## Project 1: Lynden Birth Center

## Project Comment Form

**Project Title:** New Birth Center Renovation

## Project Comment Form

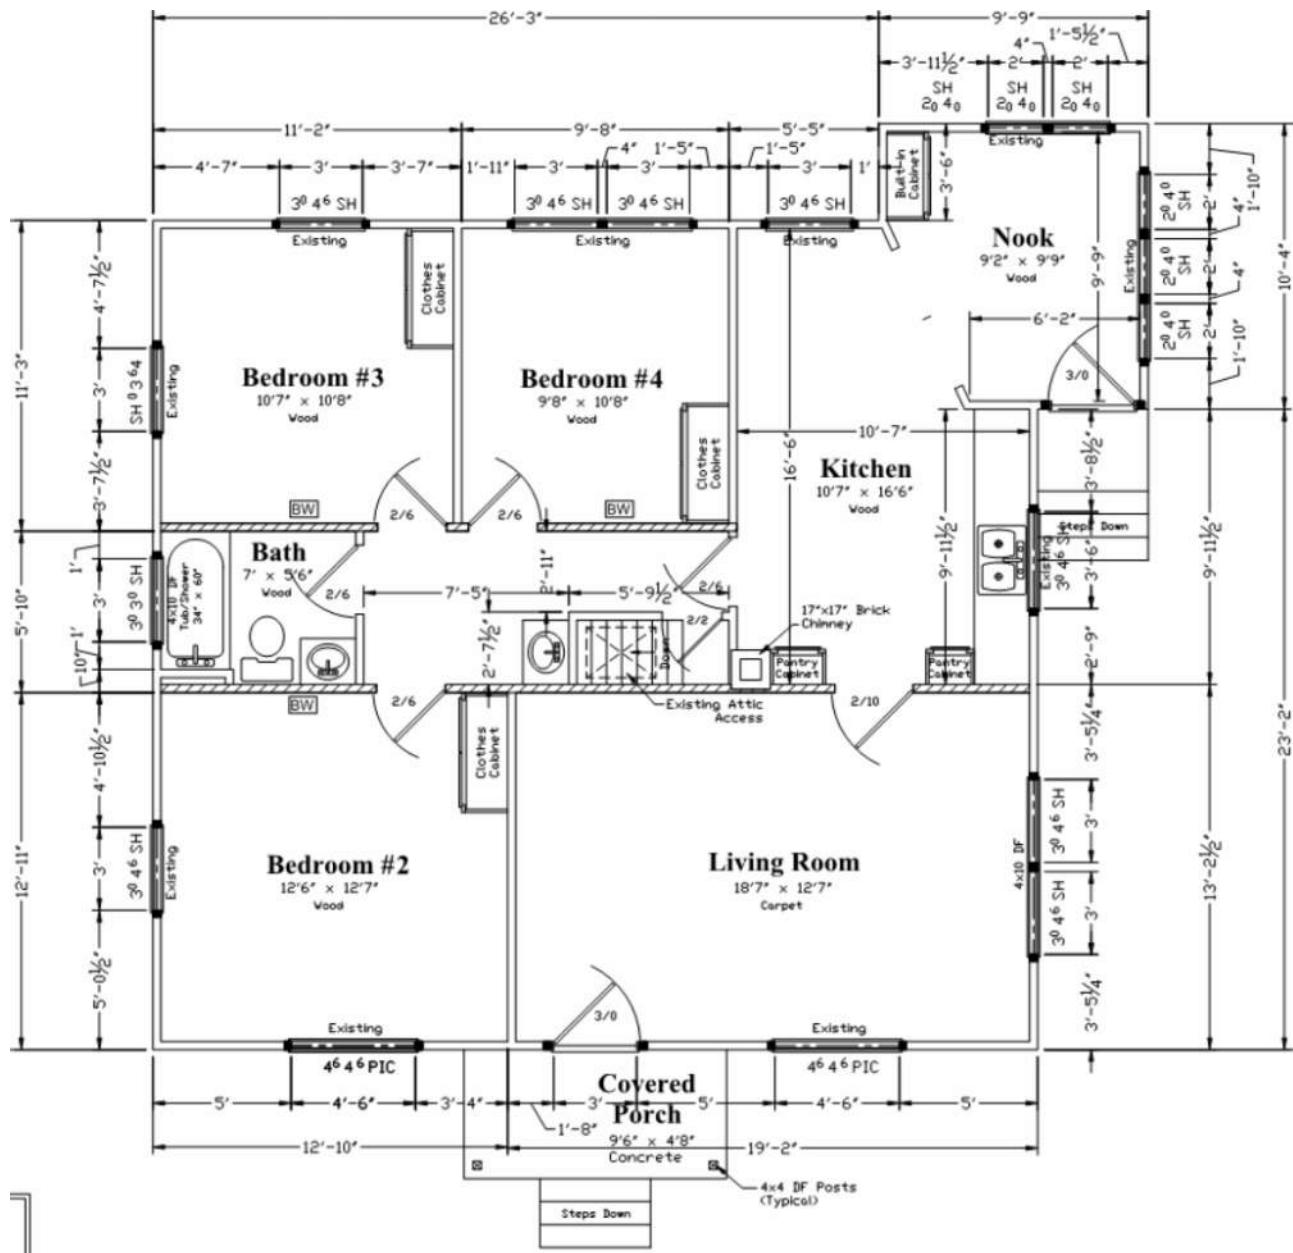
T1	The applicant seeks to convert an existing building, plan included in this doc, into a licensed birth center meeting the physical environment standards of the 2006 FGI under the provisions of WAC 246-329-160(15)
T2	<p><a href="#">WAC 246-329-065</a> describes the review process and requires the applicant provide construction documents to DOH/CRS for review. ‘Construction documents’ are written, graphic, and pictorial documents prepared to describe the physical characteristics of the project and demonstrate compliance with applicable building code and licensing requirements.</p>
T3	<p>CRS reviews the construction documents for proposed birth centers to the general design and construction standards of the building codes and the specific functional requirements of the licensing rules.</p> <ul style="list-style-type: none"><li>• The general design and construction requirements are set forth in state building code adopted and amended by the state building code council, including, but not limited to:<ul style="list-style-type: none"><li>○ The International Building, Fire, Mechanical, and Existing Building Codes (IBC, IFC, IMC, IEBC respectively)<ul style="list-style-type: none"><li>▪ These codes are available for free view as read-only documents at: <a href="https://codes.iccsafe.org/category/Washington?year[]&amp;Current+Adoption&amp;page=1">https://codes.iccsafe.org/category/Washington?year[]&amp;Current+Adoption&amp;page=1</a></li></ul></li><li>○ The Uniform Plumbing Code (UPC)<ul style="list-style-type: none"><li>▪ <a href="https://www.iapmo.org/publications/read-uniform-codes-online/">https://www.iapmo.org/publications/read-uniform-codes-online/</a></li></ul></li><li>○ State amendments to the above codes can be found at: <a href="https://apps.leg.wa.gov/WAC/default.aspx?cite=51">https://apps.leg.wa.gov/WAC/default.aspx?cite=51</a></li><li>○ Chapter 296-46B WAC Electrical safety standards, administration, and installation.<ul style="list-style-type: none"><li>▪ <a href="https://lni.wa.gov/licensing-permits/electrical/laws-rules-policies">https://lni.wa.gov/licensing-permits/electrical/laws-rules-policies</a></li></ul></li></ul></li><li>• The specific licensing requirements are provided in <a href="#">WAC 246-329 Childbirth Centers</a> and the 2006 edition of the <i>Guidelines for Design and Construction of Health Care Facilities</i></li><li>• Elements of the physical environment not specifically addressed in the WAC or FGI are reviewed to the requirements of the building code as adopted by the state building code council.</li></ul> <p>WAC 246-329-065(1)(a)</p>

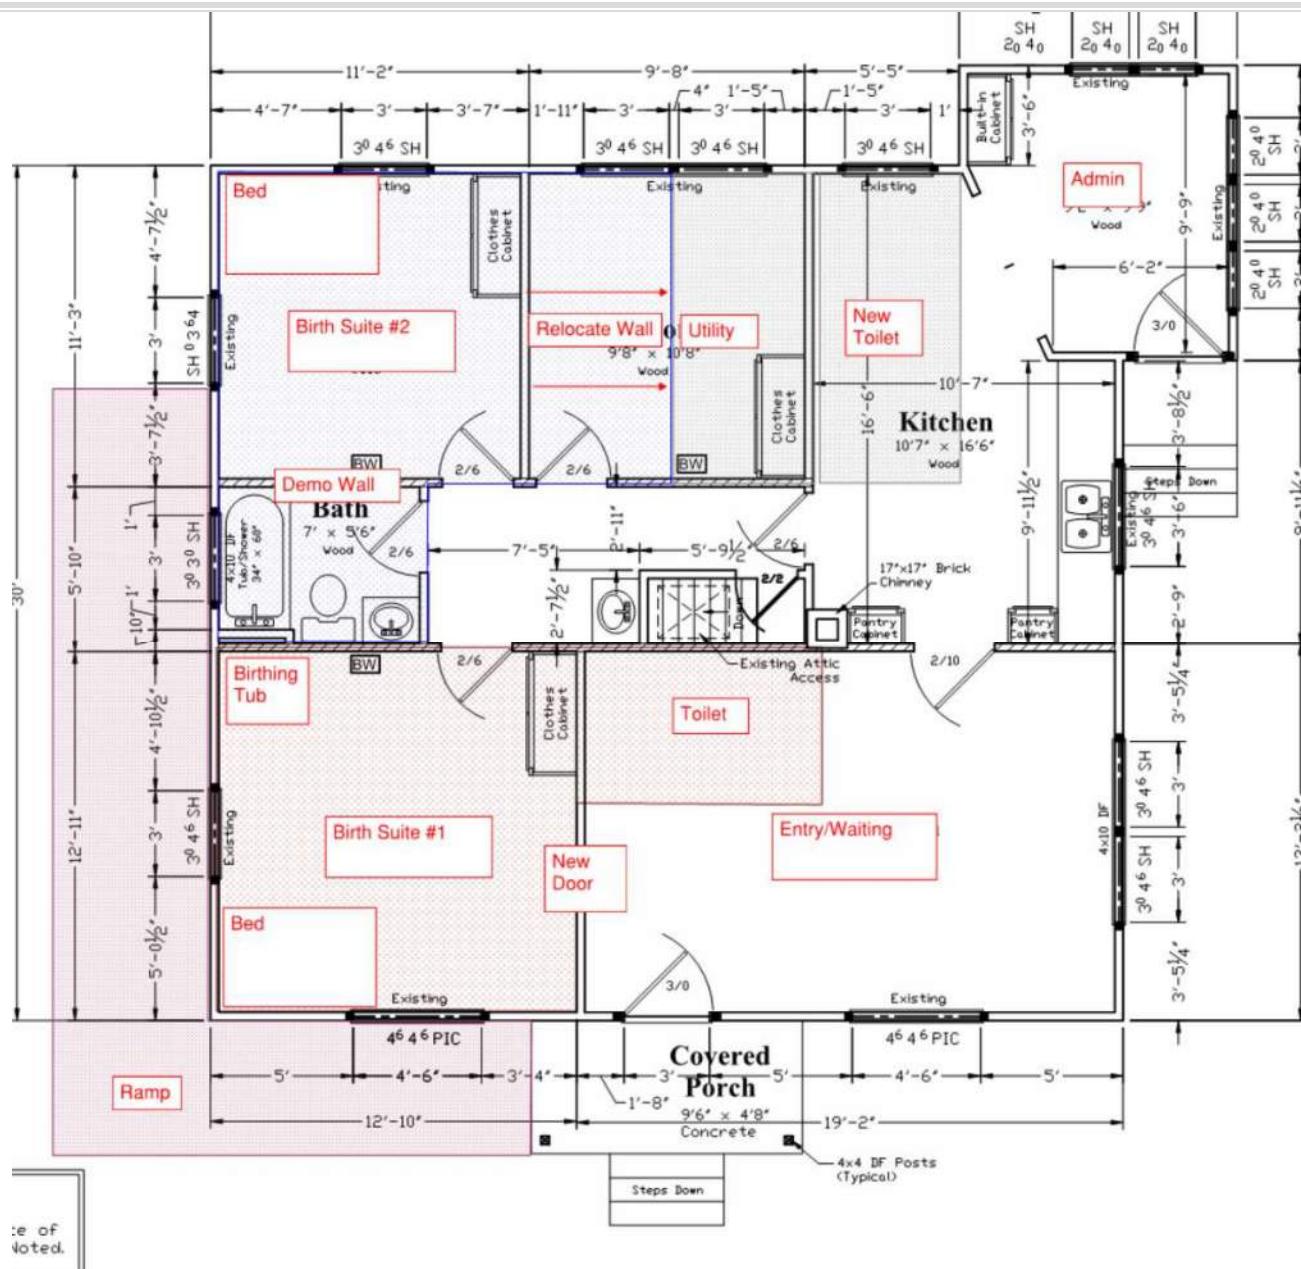
T6 Multiple design options were discussed via phone conferences and email correspondence during the course of preliminary plan review. The current conceptual design, shown below, proposes:

- The Living Room becomes the Entry and Waiting spaces
- Bedroom #2 becomes Birth Suite #1 with addition of a toilet room and door to the Waiting room
  - Toilet open to room; wall & door moved to include sink in room (not reflected in sketch).
- Bedroom #3 is enlarged and becomes Birth Suite #2
  - Door from toilet to hall closed; toilet/bath open to room
- Bedroom #4, reduced in size, becomes a Utility room
- An accessible toilet room is created in Kitchen area
- The Nook is used for administrative/clerical space

Reference diagram:

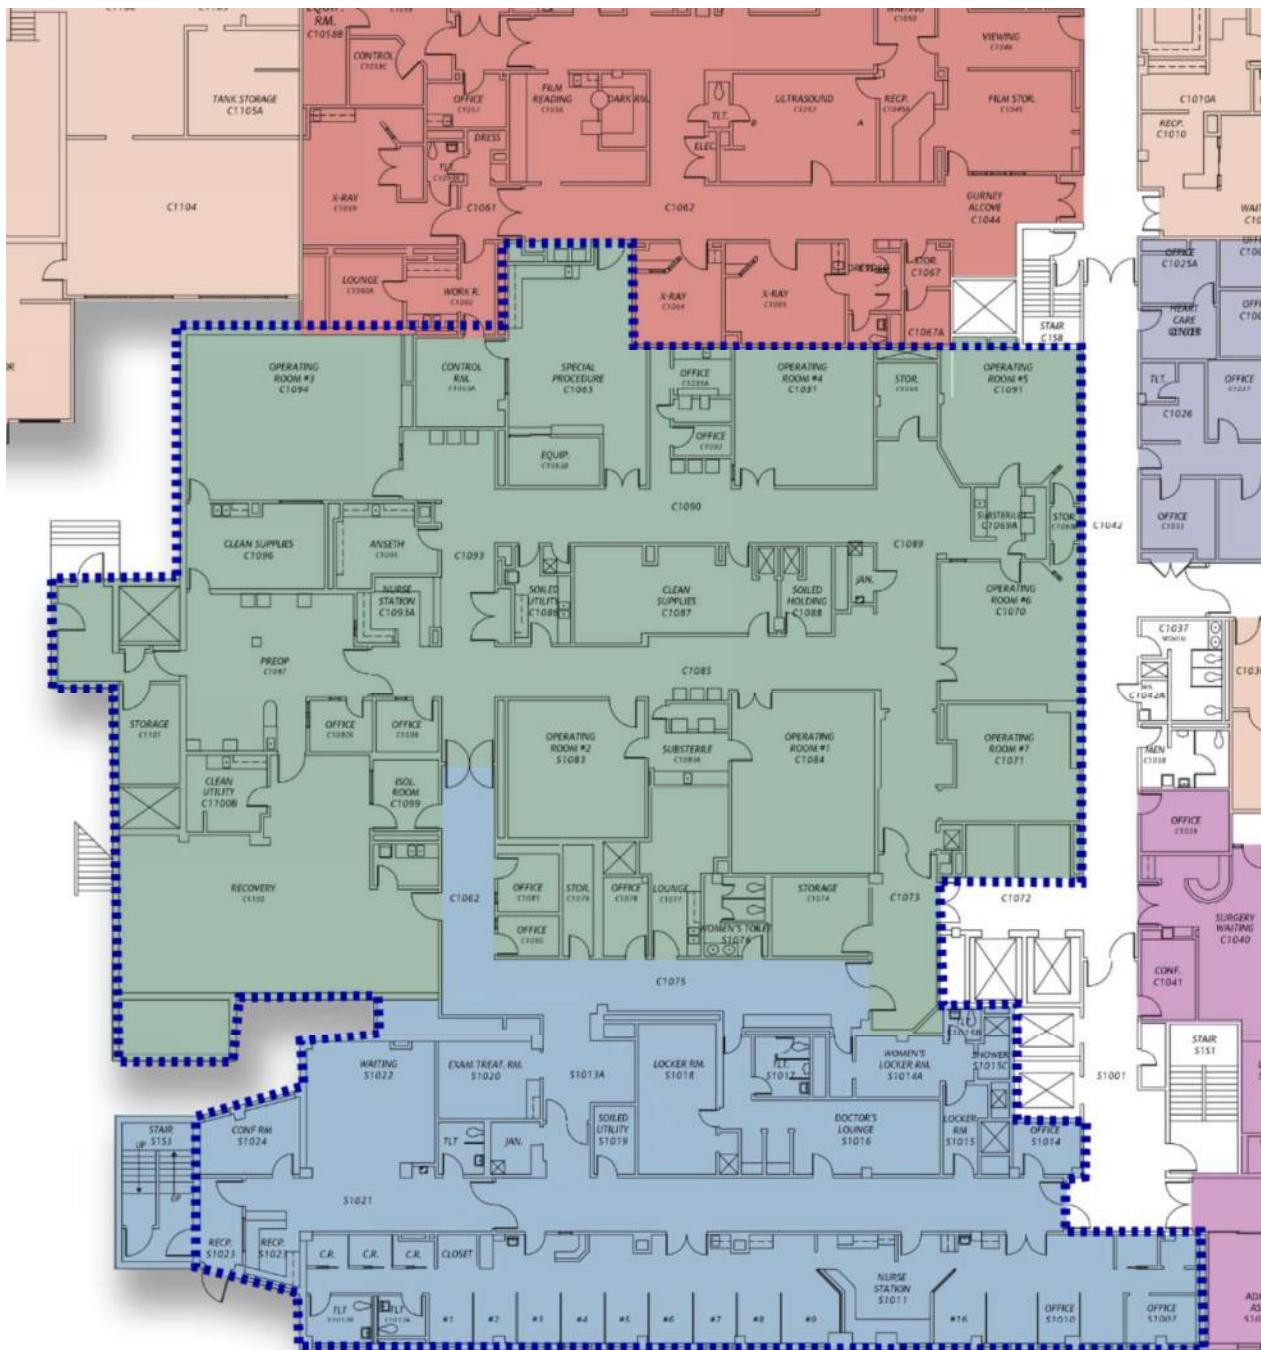
The ASC is must be separated from other facilities or operations within the same building by walls with at least a one-hour separation. NFPA 101 Life Safety Code (incorporated by cross reference at §416.44(b)).

Construction appears necessary to provide the one-hour rated separation with 45-minute rated opening protectives and assemblies. Smoke dampers are not required of ducts penetrating this assembly unless required by other elements of the building (IBC) or life safety (NFPA 101) codes.

## Reference diagram:

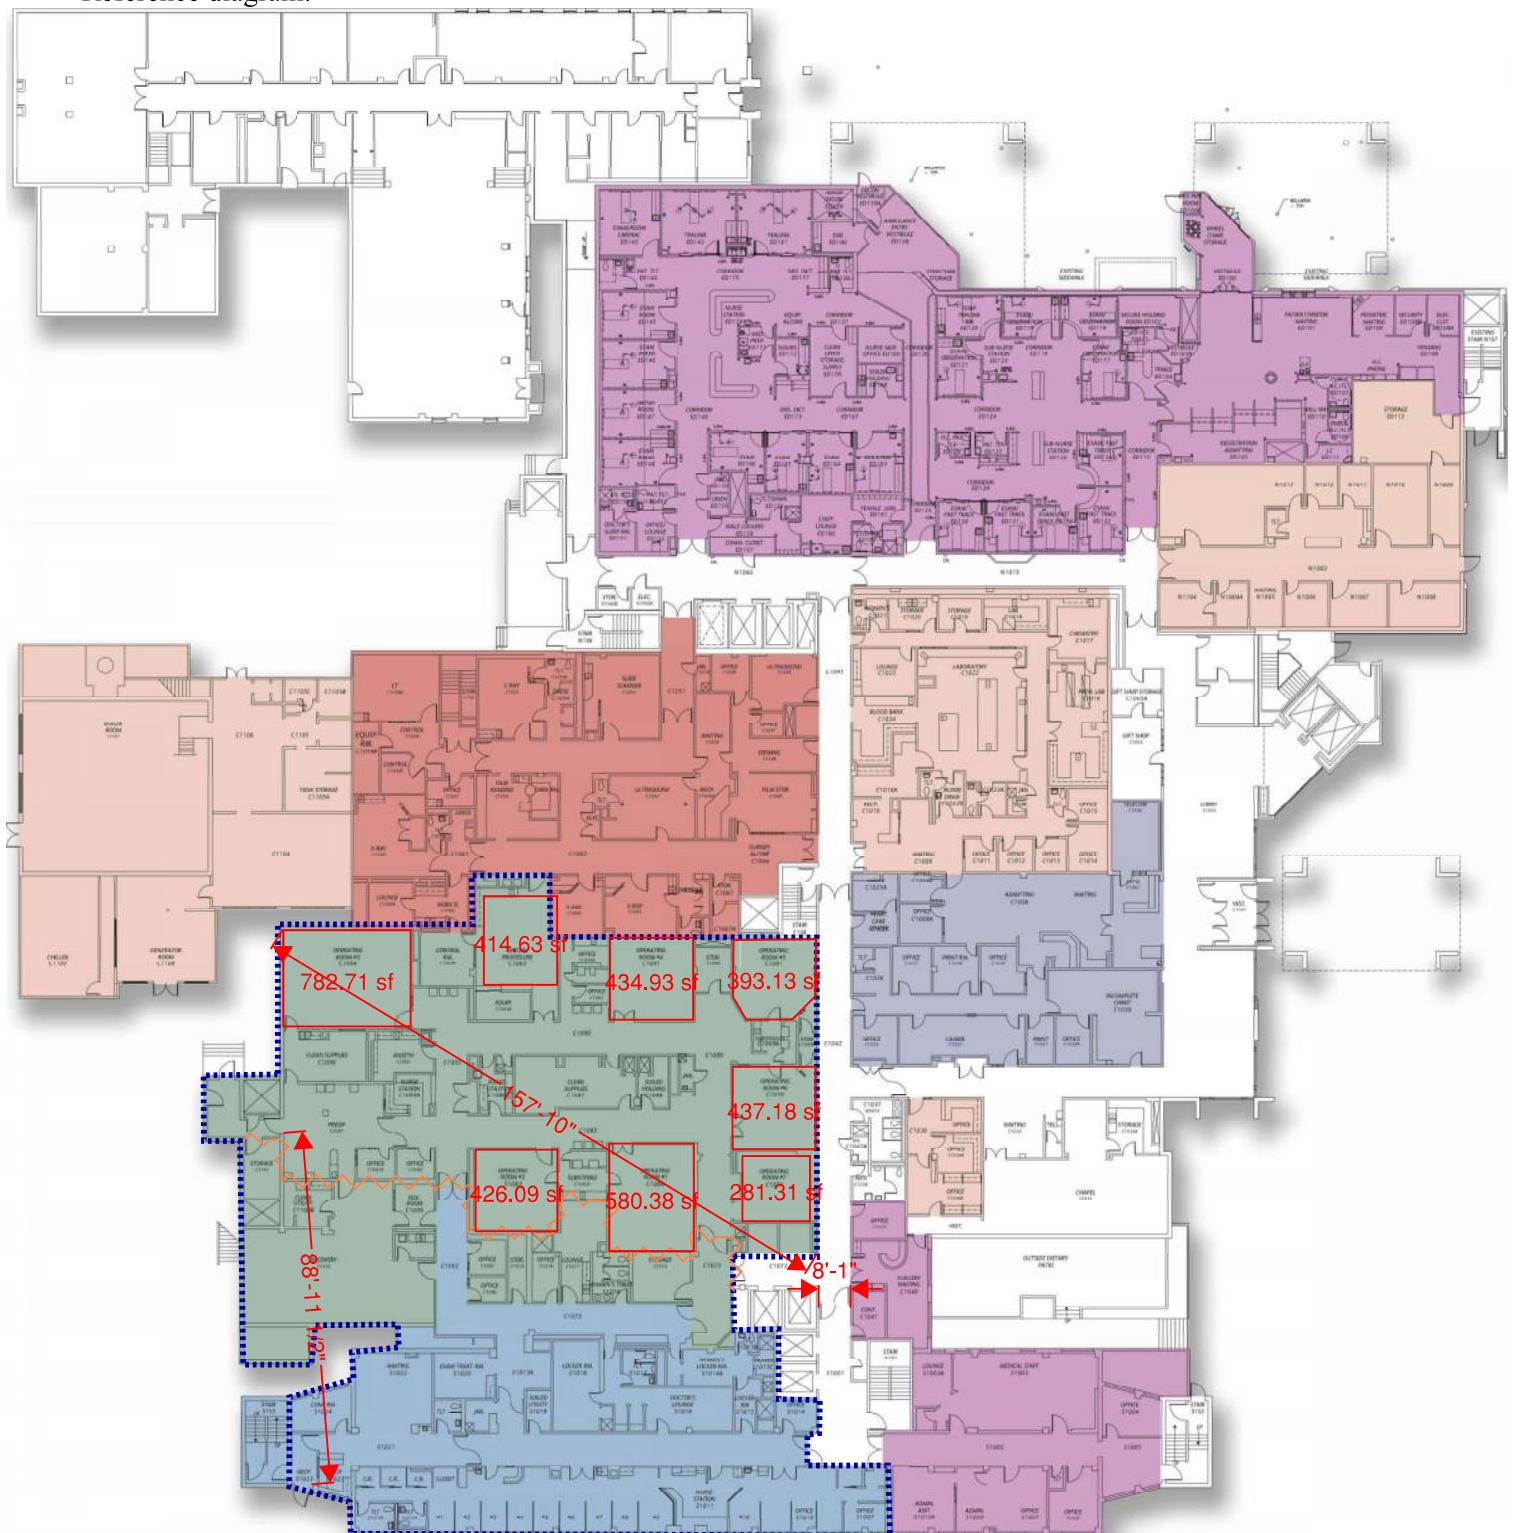
T6	<p>The manner in which the space will meet the requirements for the means of egress and exiting is not readily apparent. Reference NFPA 101: 20.2, 38.2.2, and Chapter 7</p> <ul style="list-style-type: none"><li>• Identify at least 2 exits from the building in which the ASC is located<ul style="list-style-type: none"><li>○ These must meet the applicable requirements of NFPA 101 Chapter 7<ul style="list-style-type: none"><li>▪ One exit appears indicated at Reception<ul style="list-style-type: none"><li>• The adequacy of the space for gurney / stretcher traffic cannot be determined</li></ul></li><li>▪ One exit appears indicated via passage through Pre-Op C1097<ul style="list-style-type: none"><li>• This exit does not appear compliant due to the swing of the exit door over the landing; design of stairs not known.</li></ul></li></ul></li><li>○ Measure travel distances from established compliant exits to demonstrate the travel distance from any point in a room in the ASC is less than 200 from an exit. NFPA 101: 20.2.6.2</li></ul></li><li>• Identify exits from the ASC<ul style="list-style-type: none"><li>○ These must be located to limit dead-end conditions to 50' and limit the common path of travel distances to less than 100'. NFPA 101: 20.2.5 and 38.2.5</li><li>○ Exits from the ASC may be separate from building exits, provided the means of egress outside the ASC meet and are maintained to the requirements of the ASC.</li></ul></li><li>• Identify / clarify smoke compartmentation<ul style="list-style-type: none"><li>○ Drawings show the north smoke compartment as 'land-locked' without access to a corridor or exit except through the immediately adjacent compartment to the south. IBC 422.3.3</li></ul></li></ul>

<p>Complete evaluation of the means of egress cannot be completed based on the information provided. Availability / reliability of Corridors S1001 and C1042 as means of egress to exits and clarity regarding the location of the smoke barrier appear instrumental in design of a compliant means of egress. Next steps should be to refine the distinct entity and develop life safety plans. These appear to be 'drywall' level issues. Walls and opening protectives presumed rated must be inspected for continuity and integrity.</p>
T7	<p>The facility must develop a written plan for the protection of all persons in the event of fire, for their evacuation to areas of refuge, and for their evacuation from the building when necessary as required by NFPA 101: 20.7.1.1 through 20.7.1.3. and 20.7.1.8 through 20.7.2.3.3 and IFC 401, 403.3.1 through 403.3 and 404 through 406. The design of the means of egress must support the facilities emergency plans.</p>
